# SERVICE BULLETIN

488

Piper Aircraft Corporation

Modification of Landing Gear Selector Cable Forward Attachment Pin.

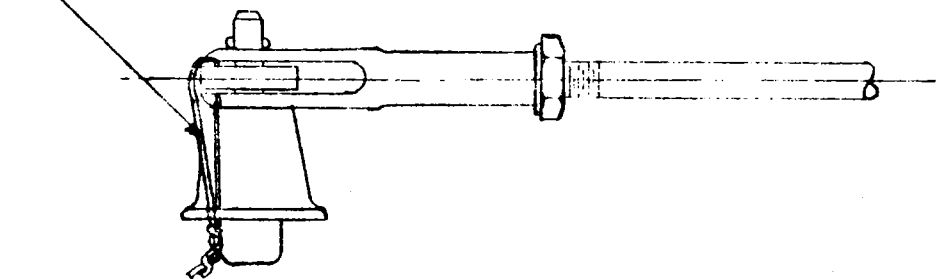
5. Safety with approximately three inches of MS20995C41 lock wire (.041 stainless steel) through the hole in the arm and existing hole in pin knob per attached sketch.

Wrap lock wire around arm on side opposite from cable, to prevent interference with cable clevis during normal operation.
